DS-K1T680 Series MinMoe Terminal Release Note (2022-04-09)

Device Model: DS-K1T680D(F)-E1 DS-K1T680D(F)W DS-K1T680D(F)G DS-K1T680D(F)G1 Naming Rule: D for M1 card, Desfire card, Felica card E1 for POE, W for Wi-Fi, F for fingerprint G1 for 3/4G, supported in Australia, Taiwan (China) and Latin America; G for 3/4G, supported in Europe, the Middle East, Africa, India, and Most Areas of Asia-Pacific (excluding Japan and Taiwan (China))	Firmware Version	ARM : ACS_680_AI3_EN_ STD _V3.2.35_build2 20315 ACS_680_AI3_EN_ NEU _V3.2.35_build2 20315
	SDK	Latest version
	iVMS-4200 Version	Latest version

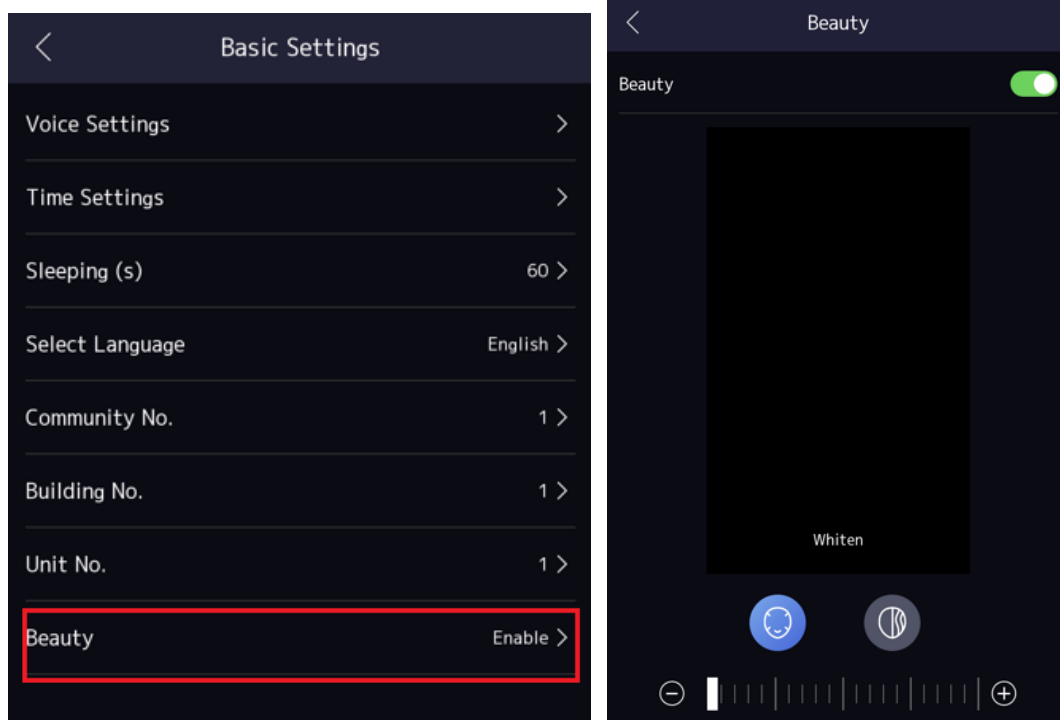
- Support **advertisement mode**: upload pictures from web and always display on the screen, recommend using company logo or advertisement picture.

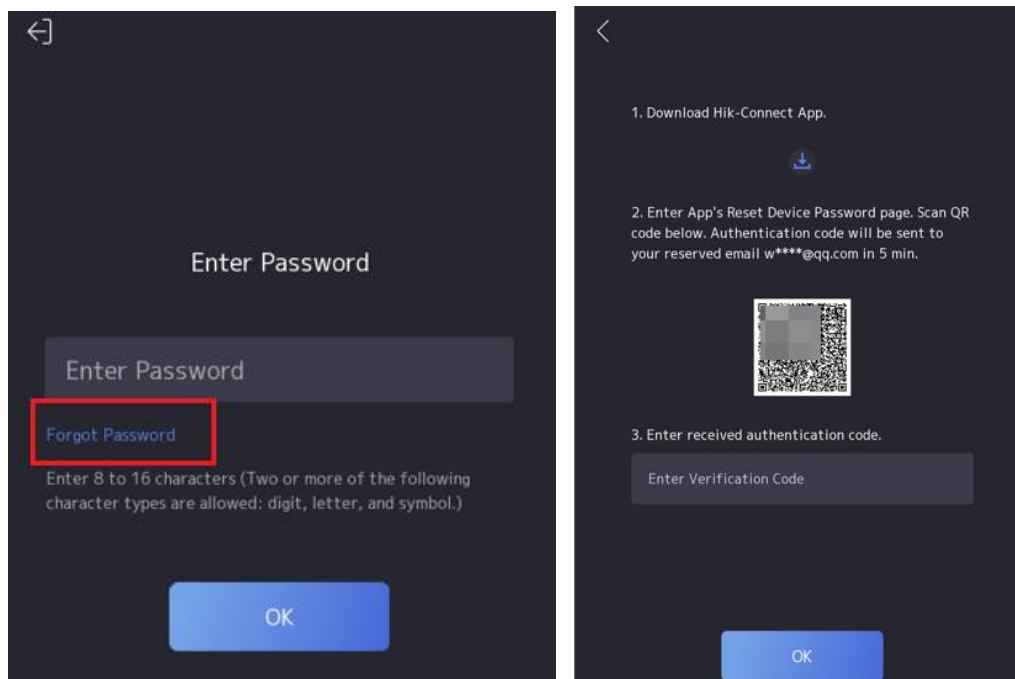
5. Support beauty function

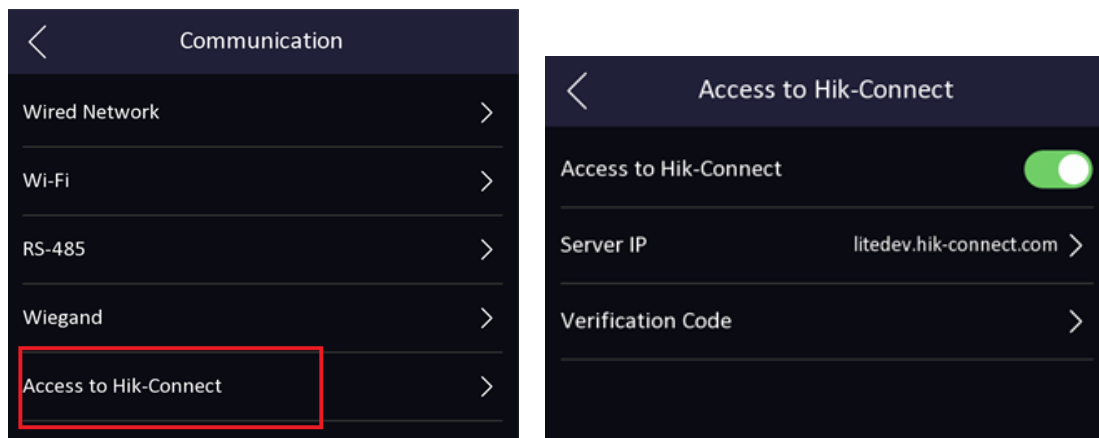
1. Add Hik-Connect menu in device UI Menu→Comm. The function is disabled in default.

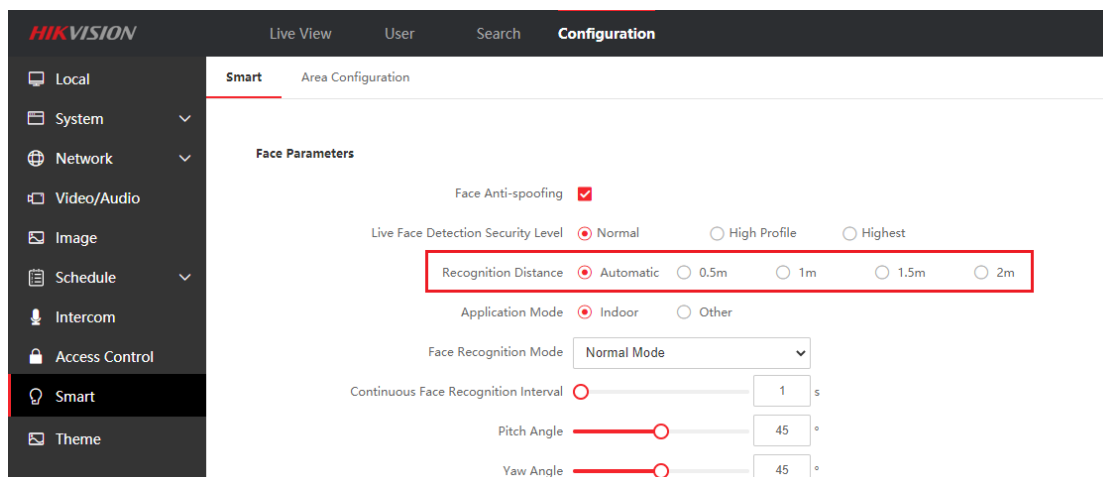
1. Optimize the wake-up distance of the device screen through the face, and the wake-up distance is consistent with the recognition distance

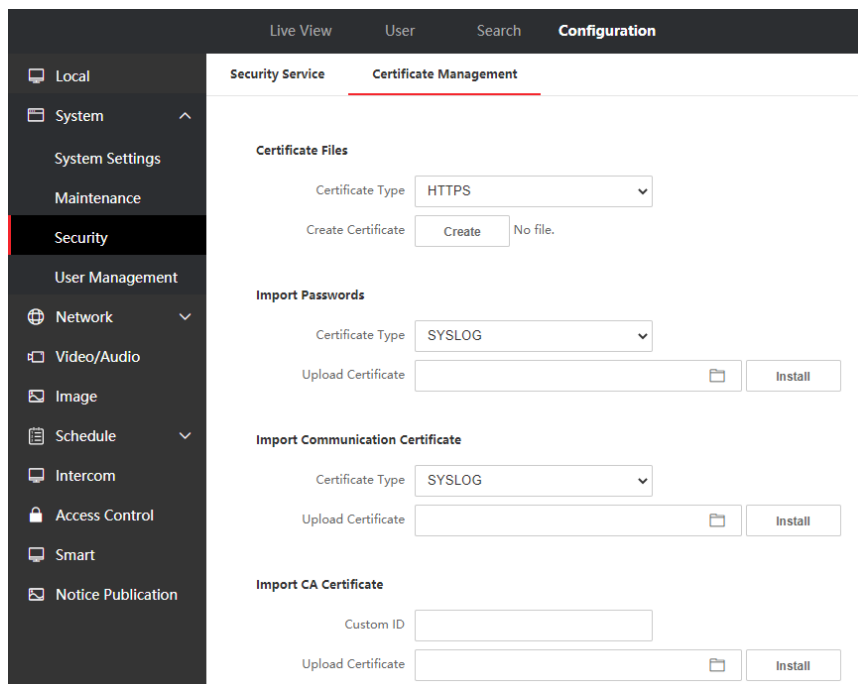
1. Support https feature

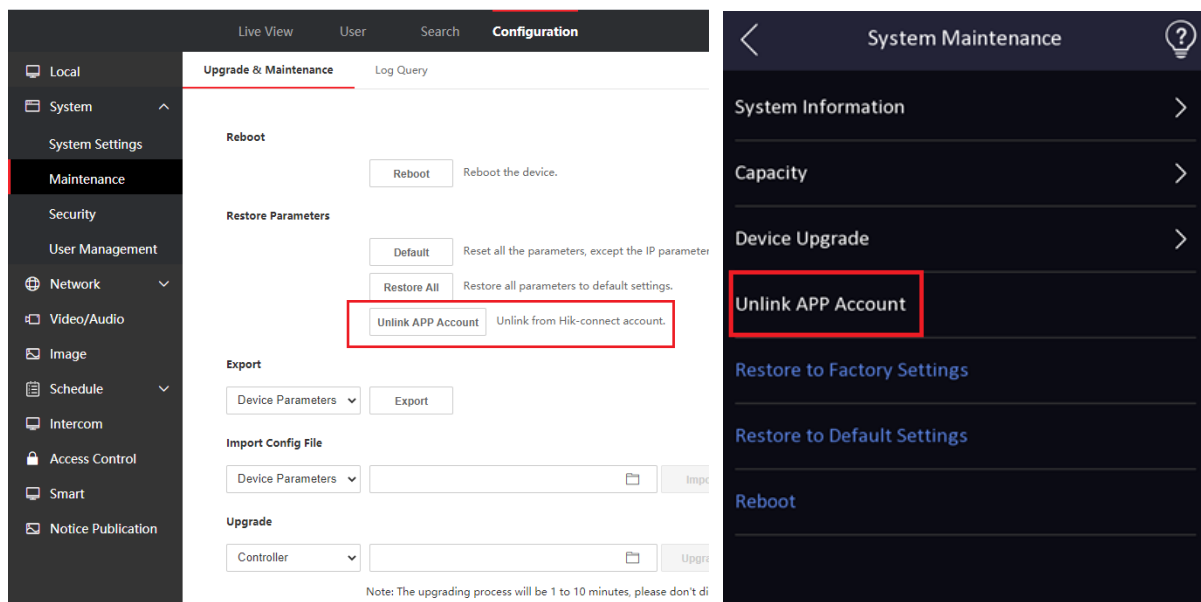
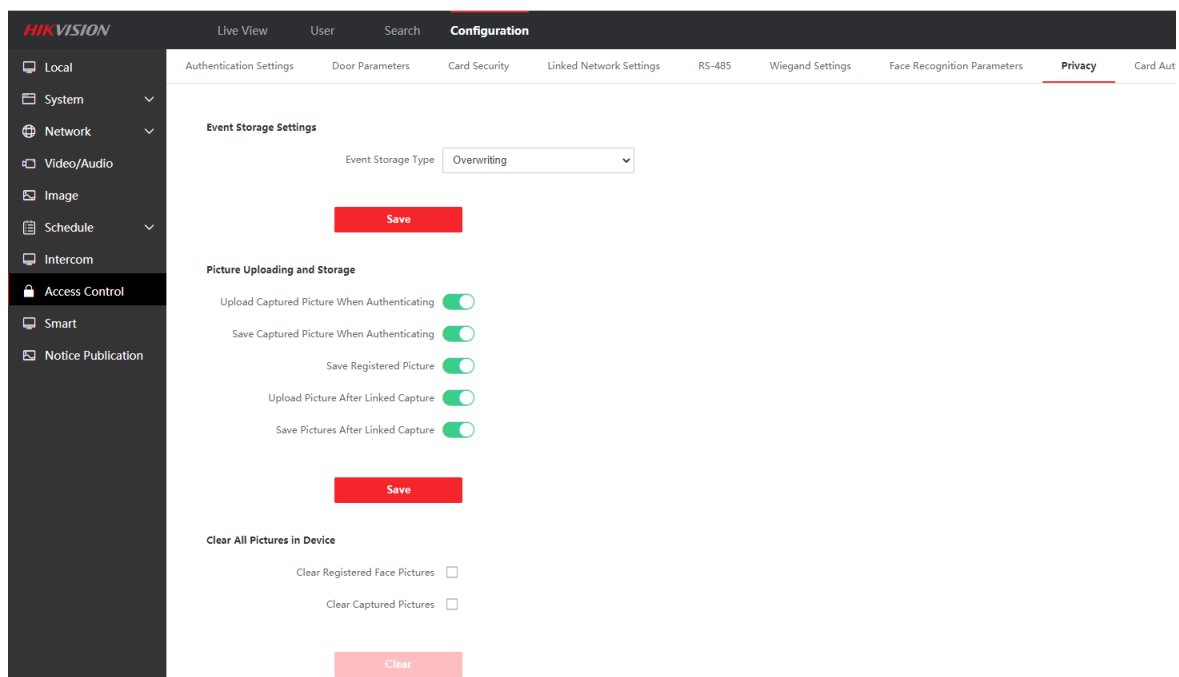
6. Support unbind device with hik-connect account on SADP tool, local UI and web

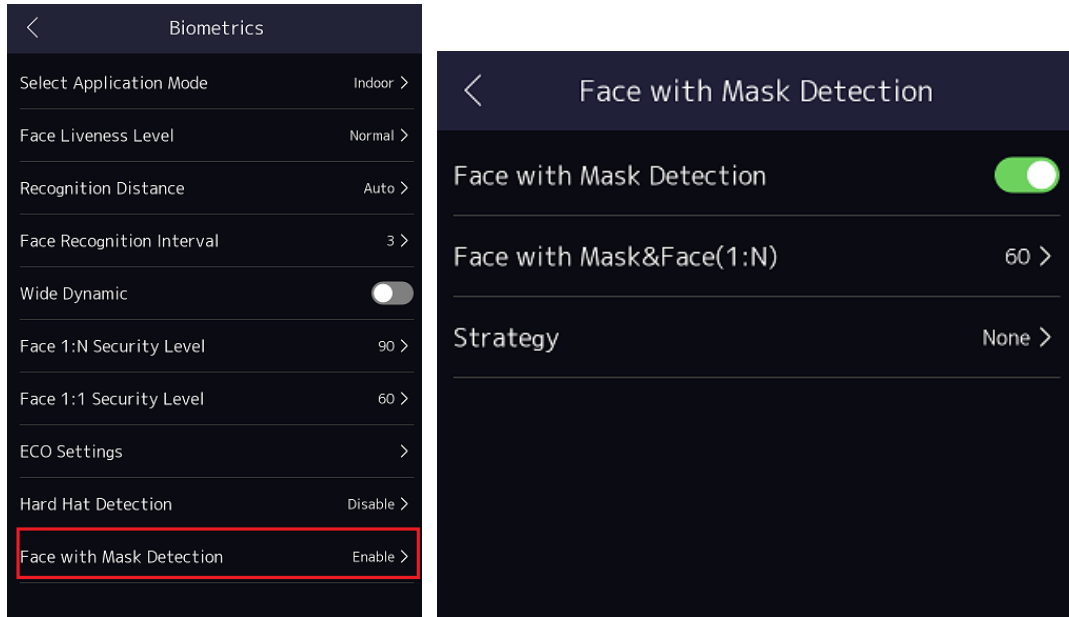
7. Add privacy protection, support event Storage Settings, Picture Uploading and Storage, Clear All Pictures in Device

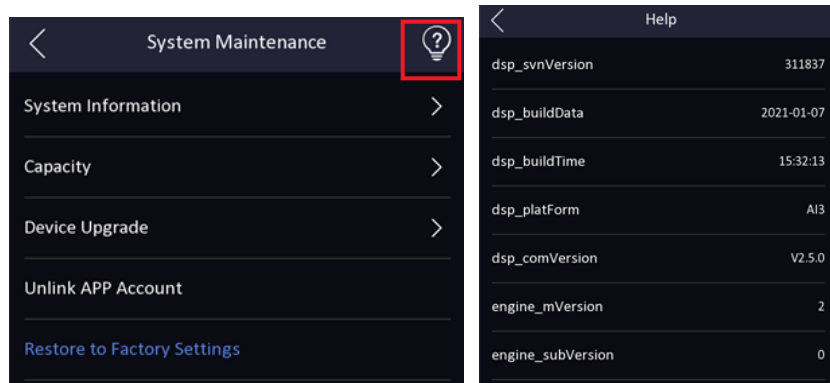
8. Add face mask detection function(enabled in default);

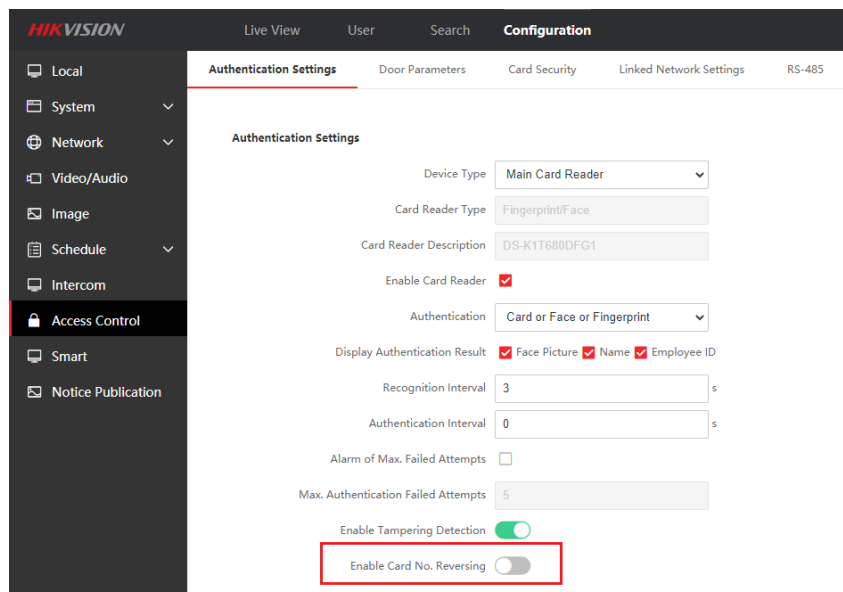
9. Add help interface to check system module version for technical support (long press for 3s).

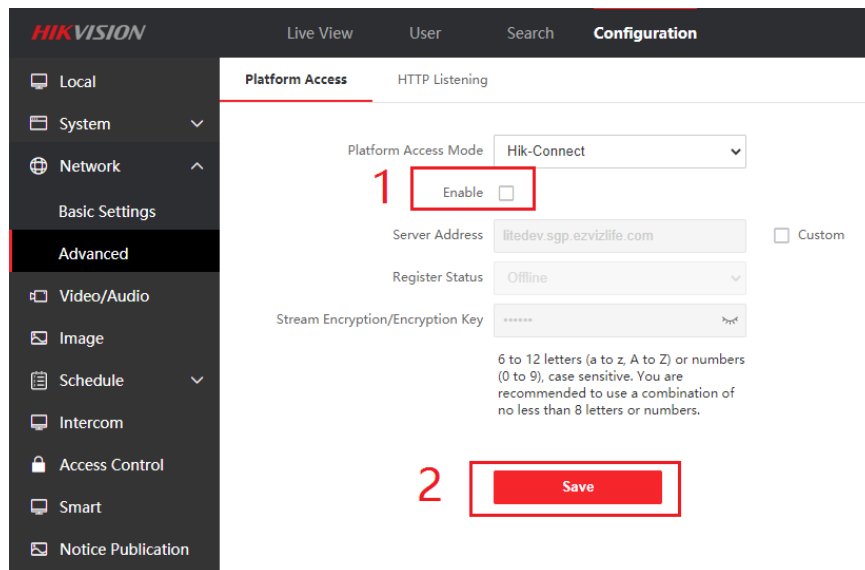
10. Add card No. reversing function (external reader not support)

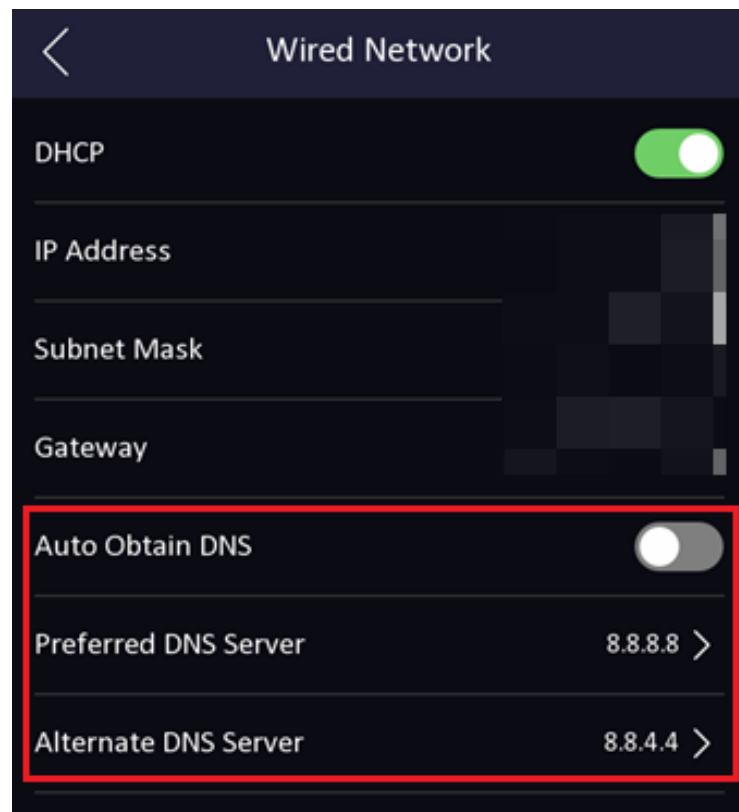
- Hik-Connect function is turned off in default for privacy protection, if customer want to manage device from App, please turn on manually in the web.

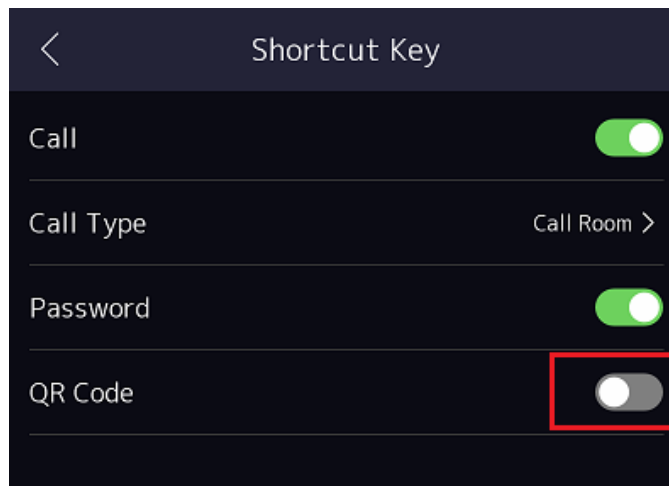
- DNS can be configured from device UI in menu → Comm.-->Wired Network

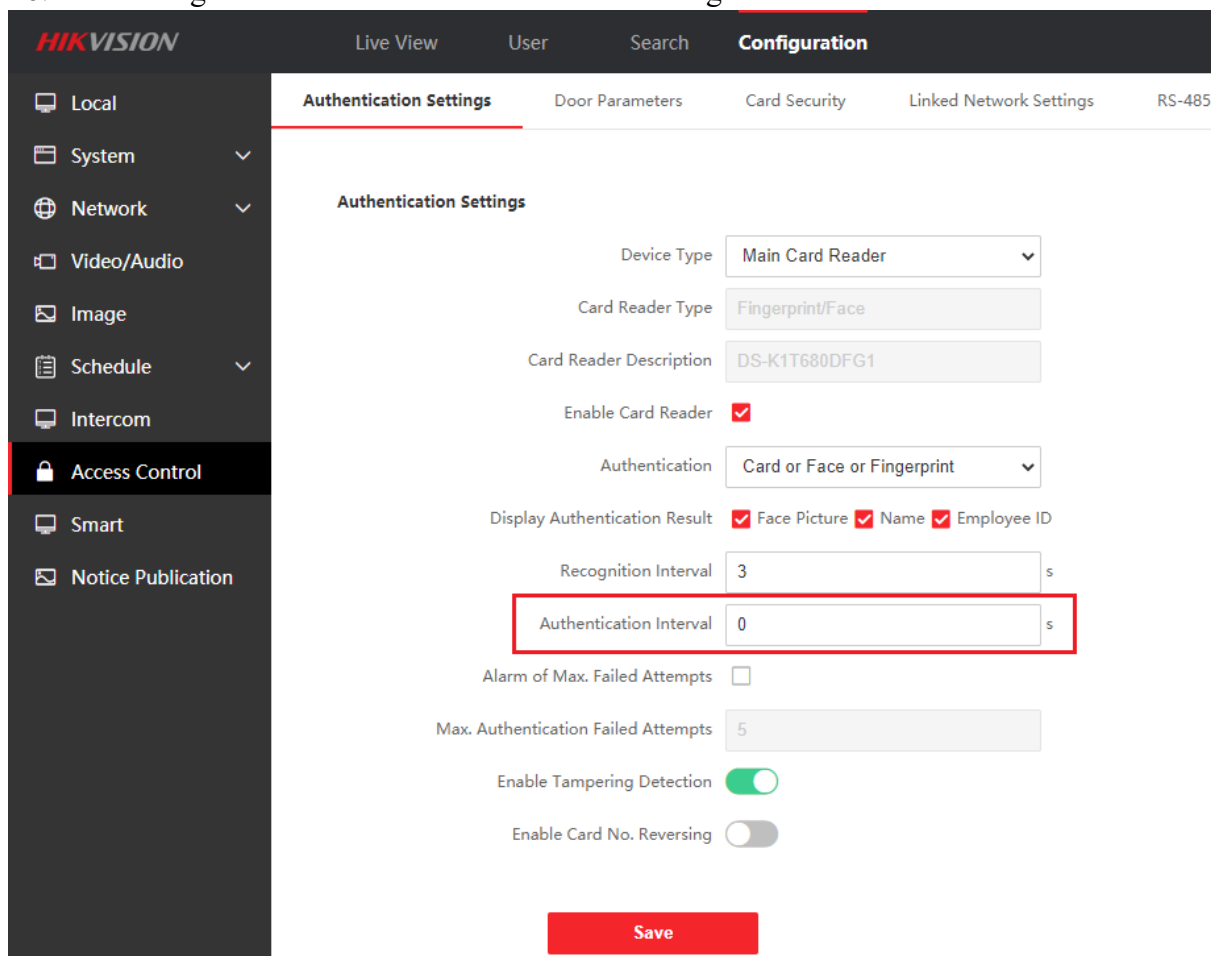
- After disable QR code shortcut from the menu, device will support QR code and face verification at the same time.
